# DrawDiff Comparison Report

Part number: DA1840189 | Job: d7991738-6858-49be-a585-d7e79417e8af | Generated: 2026-04-28T18:27:29+00:00

The revision of DA1840189 from TS to Rev A represents a significant drawing restructuring: the original isometric and auxiliary views (ISO\_1, ISO\_2, VIEW\_1, SIDE, VIEW\_8) have been replaced by a new view set (ISO\_FRONT, ISO\_REAR, MAIN\_TOP, SECTION A-A, SECTION B-B, ANNOTATION), which substantially changes how the part geometry is documented and must be verified for completeness. Most critically, the left isometric view in the revised drawing appears to show the top-center raised boss or protrusion as flattened or removed — a potential functional geometry change that requires immediate design authority confirmation before release. Additionally, the pocket corner radius count was halved from 16X R.030 to 8X R.030 in Section C-C, which may reflect a re-specification of applicable corners or an actual reduction in corner breaks, with direct implications for stress concentration and machining setup. Supporting changes include a terminology update from 'HELICOIL' to 'HELICAL INSERTS' for procurement neutrality and addition of a proprietary markin

ANNOTATION [MATCHED]

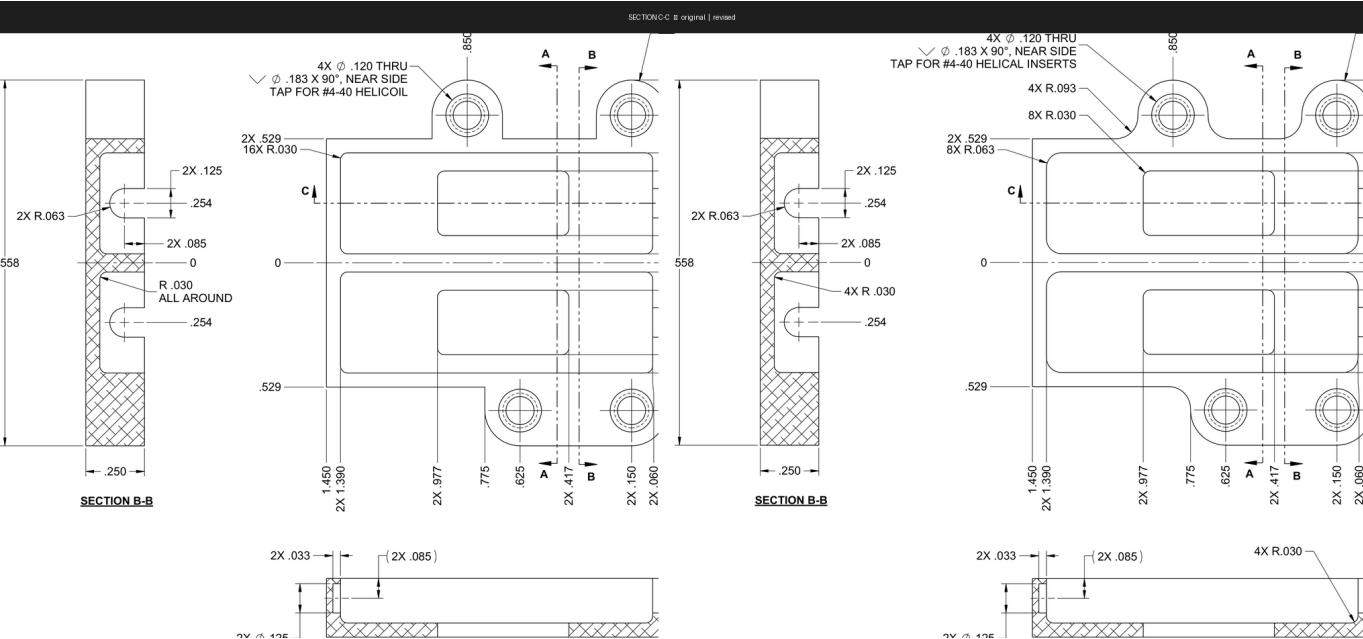
| Severity    | Field      | Original                                                                               | Revised                                                                                                                 | Conf. | Rationale                                                                                                                                                                                                                                                                                                                                                                                                                                                                       |
|-------------|------------|----------------------------------------------------------------------------------------|-------------------------------------------------------------------------------------------------------------------------|-------|---------------------------------------------------------------------------------------------------------------------------------------------------------------------------------------------------------------------------------------------------------------------------------------------------------------------------------------------------------------------------------------------------------------------------------------------------------------------------------|
| CRITICAL    | geometry   | Left isometric view shows a raised boss or protrusion at the top-center of the bracket | Left isometric view shows the top-center area without the same raised boss feature (geometry appears flattened/removed) | 0.65  | <p>The top-center region of the left isometric view appears to show a geometric difference—a raised feature visible in the original appears reduced or absent in the revised view, which could indicate a design change to the part geometry.</p> <p><b>Impact:</b> Possible removal of a functional boss feature at the top-center of the part; if real, this affects mating interfaces and structural load paths — design authority sign-off required before manufacture.</p> |
| SIGNIFICANT | annotation | REV: NC                                                                                | REV: A                                                                                                                  | 0.95  | <p>The drawing revision level in Note 3 (P/N identification block) has been updated from NC to A, indicating a formal revision increment that affects part traceability.</p> <p><b>Impact:</b> Formal revision increment from NC to A updates part traceability and triggers configuration management obligations; all affected assemblies and BOMs referencing this part number must be reviewed.</p>                                                                          |
| MINOR       | note       | —                                                                                      | PROPRIETARY AND CONFIDENTIAL (added to top of sheet)                                                                    | 0.90  | <p>A 'PROPRIETARY AND CONFIDENTIAL' marking has been added to the top of the revised sheet, which is a documentation/legal annotation not present in the original.</p> <p><b>Impact:</b> Documentation-only addition of a legal/IP marking; no manufacturing or functional impact.</p>                                                                                                                                                                                          |

SECTION C-C [MATCHED]

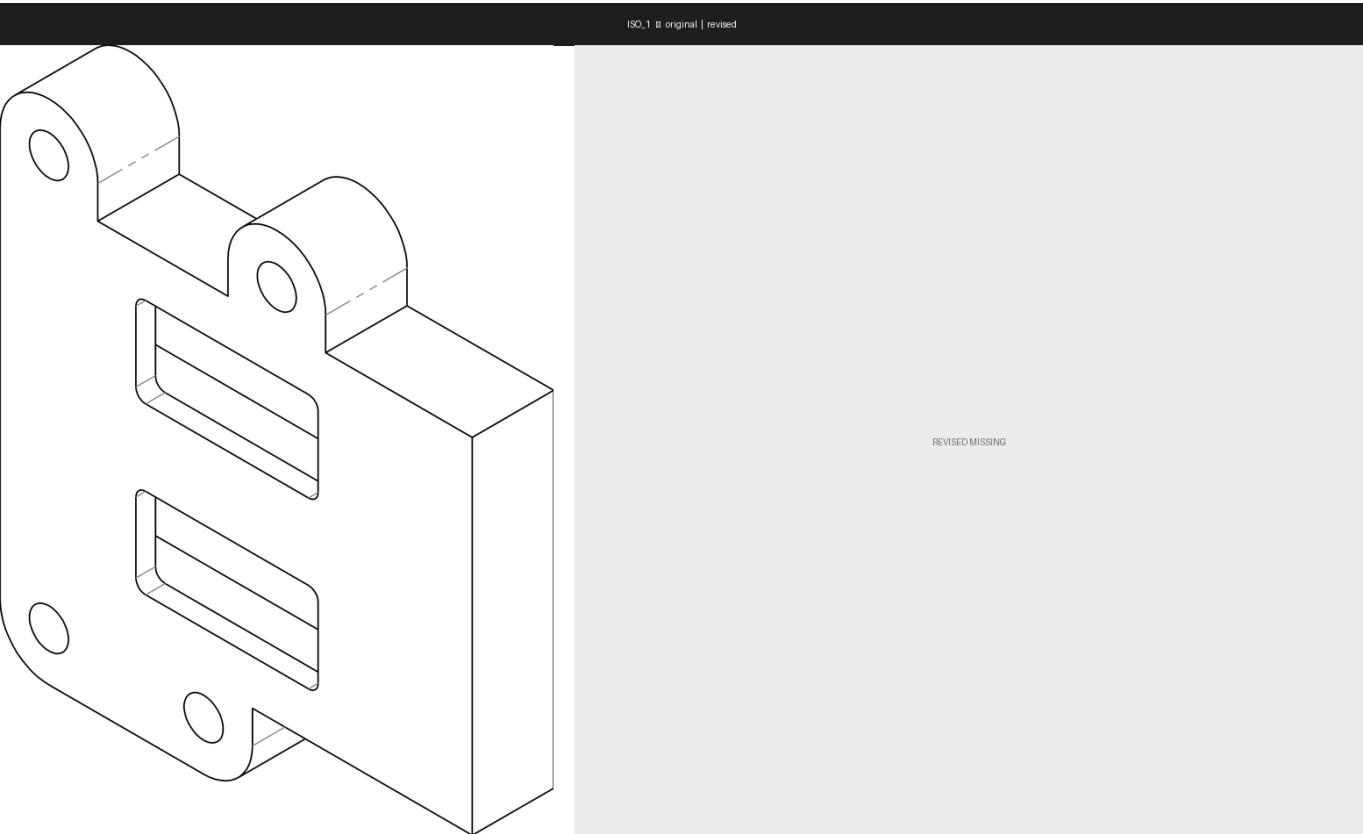
| Severity    | Field      | Original               | Revised                       | Conf. | Rationale                                                                                                                                                                                                                                                                                                                                                                                                                                                  |
|-------------|------------|------------------------|-------------------------------|-------|------------------------------------------------------------------------------------------------------------------------------------------------------------------------------------------------------------------------------------------------------------------------------------------------------------------------------------------------------------------------------------------------------------------------------------------------------------|
| SIGNIFICANT | annotation | 16X R.030              | 8X R.030                      | 0.92  | <p>The count of R.030 corner radii on the rectangular pockets changed from 16X to 8X, indicating a change in how pocket corners are specified or the number of applicable corners has been halved.</p> <p><b>Impact:</b> Halving the called-out R.030 pocket corner count may leave eight corners unspecified or indicate a geometry change; machinist must confirm which corners are affected to avoid stress risers or non-conforming sharp corners.</p> |
| MINOR       | note       | TAP FOR #4-40 HELICOIL | TAP FOR #4-40 HELICAL INSERTS | 0.95  | <p>The thread insert callout terminology changed from 'HELICOIL' (brand name) to 'HELICAL INSERTS' (generic term); functionally equivalent but affects procurement/ specification language.</p> <p><b>Impact:</b> Brand-name replaced with generic term; functionally equivalent, but procurement and inspection procedures referencing 'HELICOIL' by name should be updated to accept any qualified helical insert.</p>                                   |

**ISO\_2 [REMOVED]**

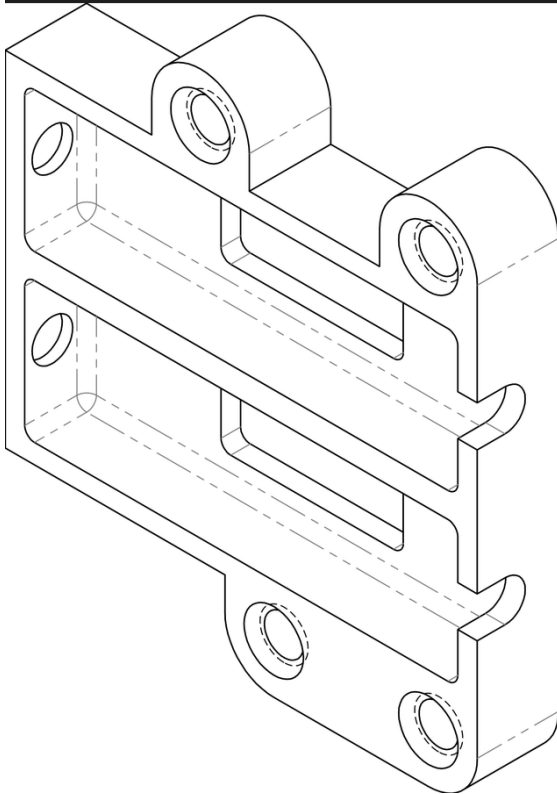
| Severity           | Field | Original | Revised | Conf. | Rationale                                                                                                                                                                                                                            |
|--------------------|-------|----------|---------|-------|--------------------------------------------------------------------------------------------------------------------------------------------------------------------------------------------------------------------------------------|
| <b>SIGNIFICANT</b> | view  | ISO_2    | —       | 1.00  | View 'ISO_2' was present in the original but not the revised drawing.<br><b>Impact:</b> Original isometric view ISO_2 removed; same coverage risk as ISO_1 — verify replacement views preserve all dimensional and feature callouts. |

**VIEW\_1** [REMOVED]

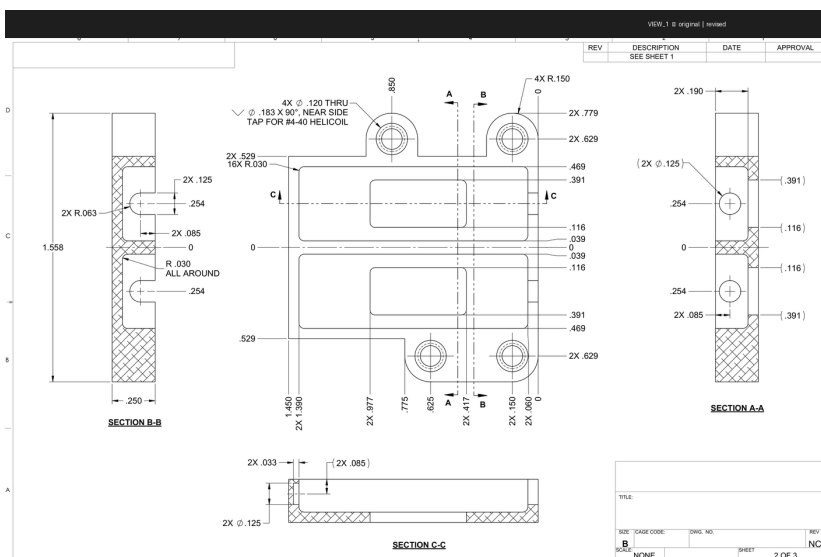
| Severity           | Field | Original | Revised | Conf. | Rationale                                                              |
|--------------------|-------|----------|---------|-------|------------------------------------------------------------------------|
| <b>SIGNIFICANT</b> | view  | VIEW_1   | —       | 1.00  | View 'VIEW_1' was present in the original but not the revised drawing. |

| Severity | Field | Original | Revised | Conf. | Rationale                                                                                                                                    |
|----------|-------|----------|---------|-------|----------------------------------------------------------------------------------------------------------------------------------------------|
|          |       |          |         |       | <b>Impact:</b> Auxiliary view VIEW_1 removed; any dimensions or notes unique to this view must be confirmed as migrated to the new view set. |

SIDE [REMOVED]

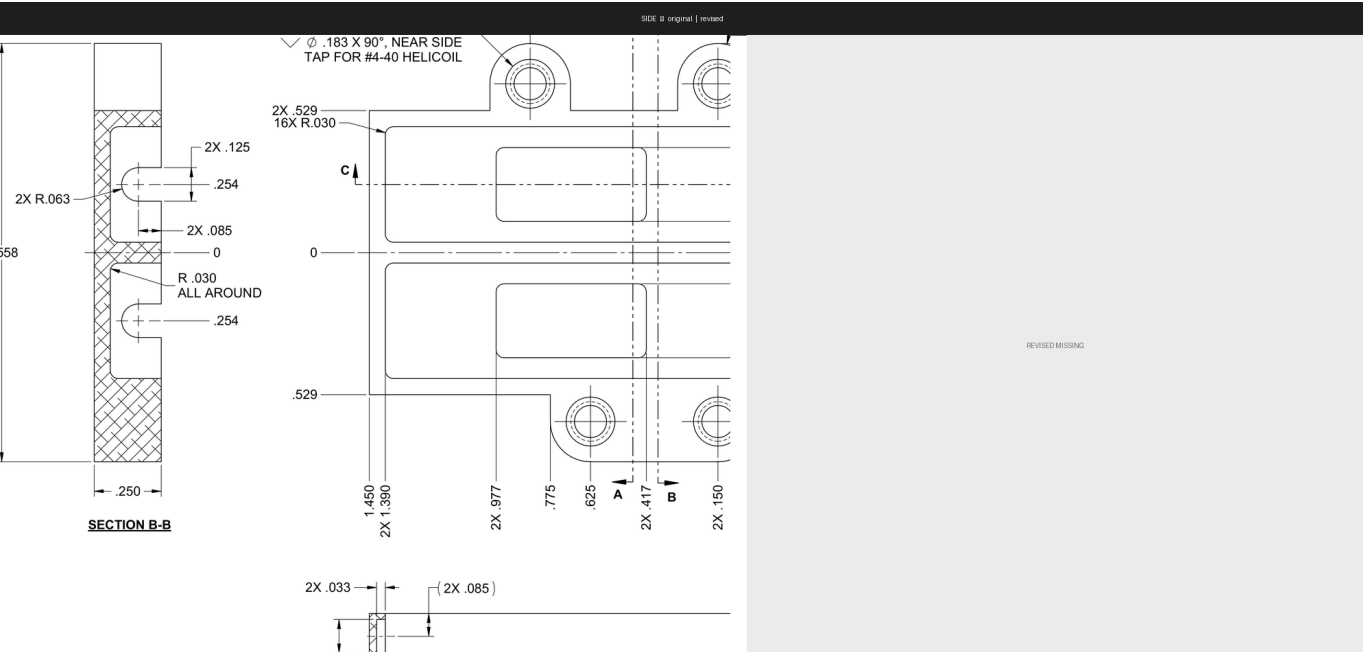
| Severity           | Field | Original | Revised | Conf. | Rationale                                                                                                                                                                                                                                    |
|--------------------|-------|----------|---------|-------|----------------------------------------------------------------------------------------------------------------------------------------------------------------------------------------------------------------------------------------------|
| <b>SIGNIFICANT</b> | view  | SIDE     | —       | 1.00  | View 'SIDE' was present in the original but not the revised drawing.<br><b>Impact:</b> Side view removed; wall thickness, slot depth, or profile dimensions previously shown here must be verified as present in Section A-A or Section B-B. |

VIEW\_8 [REMOVED]

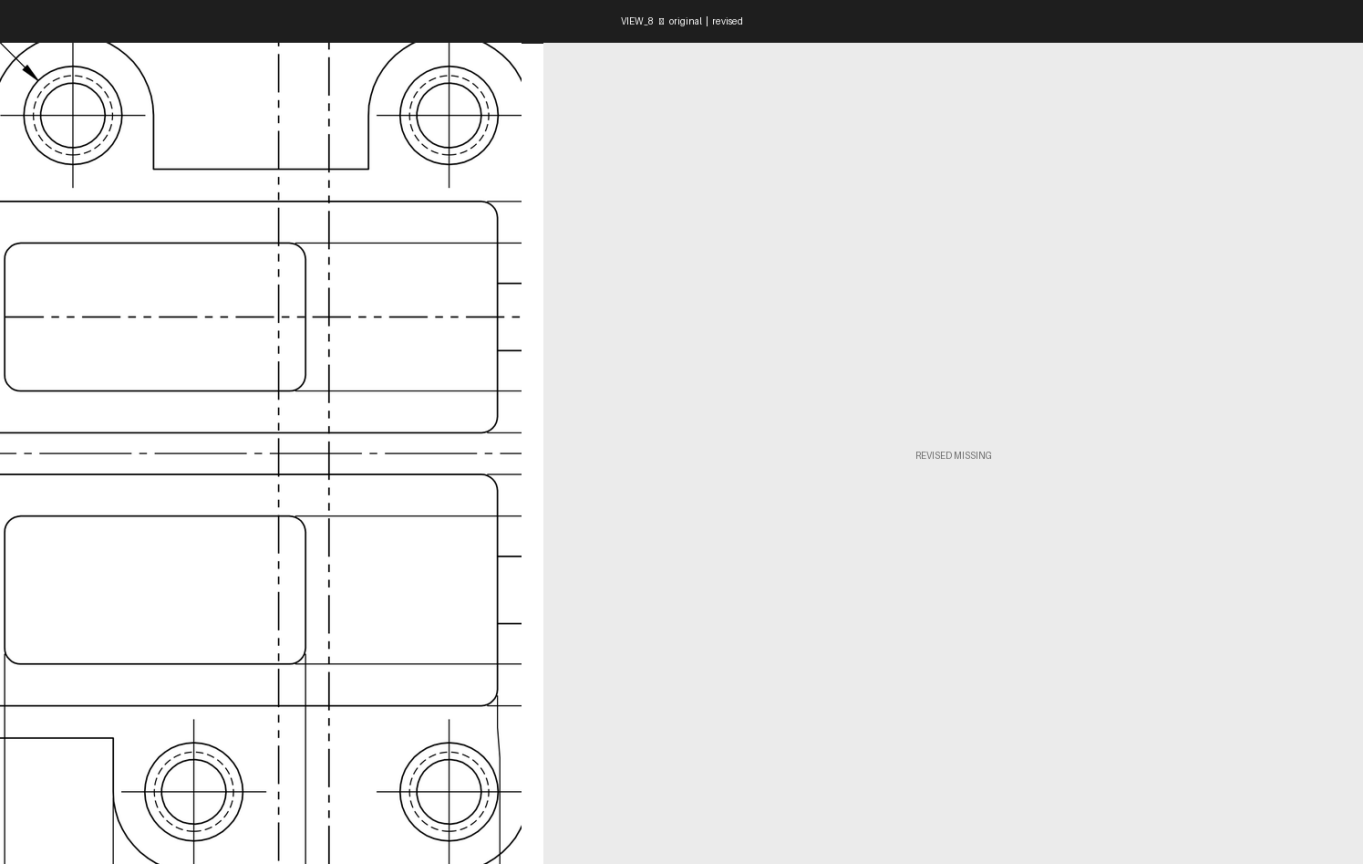
| Severity    | Field | Original | Revised | Conf. | Rationale                                                                                                                                                                                                               |
|-------------|-------|----------|---------|-------|-------------------------------------------------------------------------------------------------------------------------------------------------------------------------------------------------------------------------|
| SIGNIFICANT | view  | VIEW_8   | —       | 1.00  | View 'VIEW_8' was present in the original but not the revised drawing.<br><b>Impact:</b> Detail view VIEW_8 removed; any close-up callouts it contained must be confirmed as captured elsewhere in the revised drawing. |

ISO\_FRONT [ADDED]

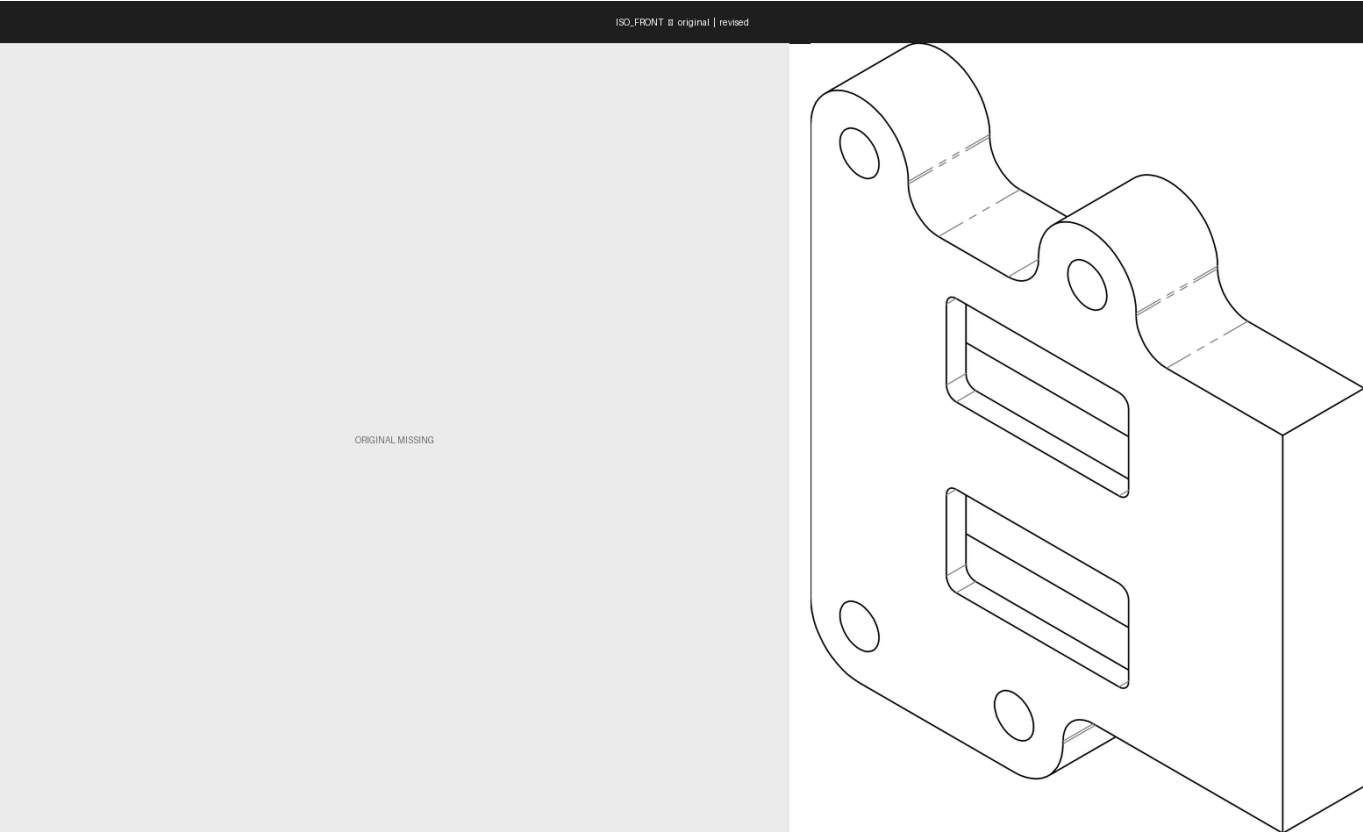
| Severity    | Field | Original | Revised   | Conf. | Rationale                                                                                                                                                                                                              |
|-------------|-------|----------|-----------|-------|------------------------------------------------------------------------------------------------------------------------------------------------------------------------------------------------------------------------|
| SIGNIFICANT | view  | —        | ISO_FRONT | 1.00  | View 'ISO_FRONT' appears only in the revised drawing.<br><b>Impact:</b> New front isometric view added; reviewer should confirm it replaces ISO_1/ISO_2 coverage and introduces no conflicting geometry or dimensions. |

## ISO\_REAR [ADDED]

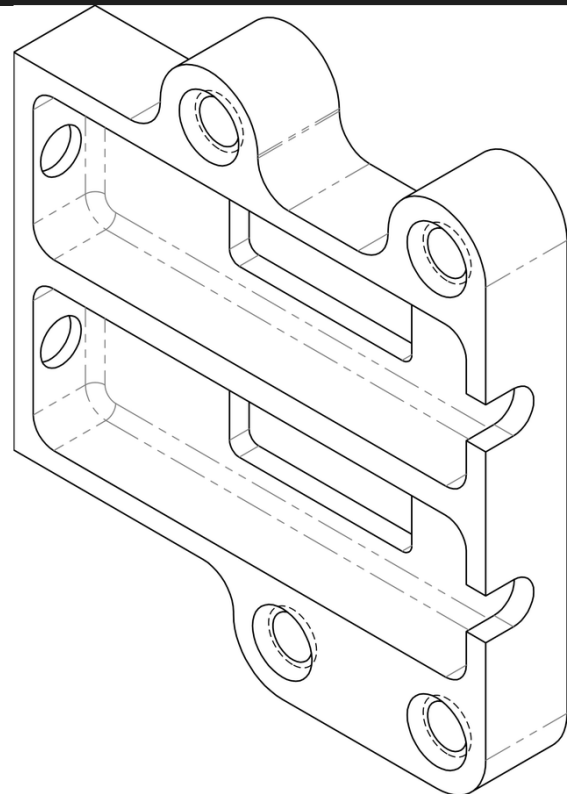
| Severity    | Field | Original | Revised  | Conf. | Rationale                                                                                                                                                                                                                 |
|-------------|-------|----------|----------|-------|---------------------------------------------------------------------------------------------------------------------------------------------------------------------------------------------------------------------------|
| SIGNIFICANT | view  | —        | ISO_REAR | 1.00  | View 'ISO_REAR' appears only in the revised drawing.<br><b>Impact:</b> New rear isometric view added; provides rear-face visibility not previously explicit — verify it does not introduce undocumented geometry changes. |

## ANNOTATION [ADDED]

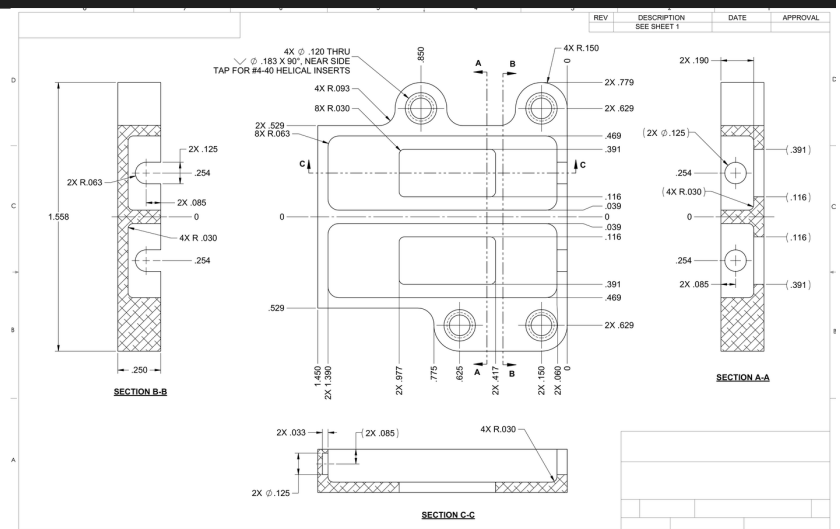
| Severity           | Field | Original | Revised    | Conf. | Rationale                                              |
|--------------------|-------|----------|------------|-------|--------------------------------------------------------|
| <b>SIGNIFICANT</b> | view  | —        | ANNOTATION | 1.00  | View 'ANNOTATION' appears only in the revised drawing. |

| Severity | Field | Original | Revised | Conf. | Rationale                                                                                                                                                    |
|----------|-------|----------|---------|-------|--------------------------------------------------------------------------------------------------------------------------------------------------------------|
|          |       |          |         |       | <b>Impact:</b> New dedicated annotation view added; documentation impact only unless it carries new or revised notes that affect manufacturing requirements. |
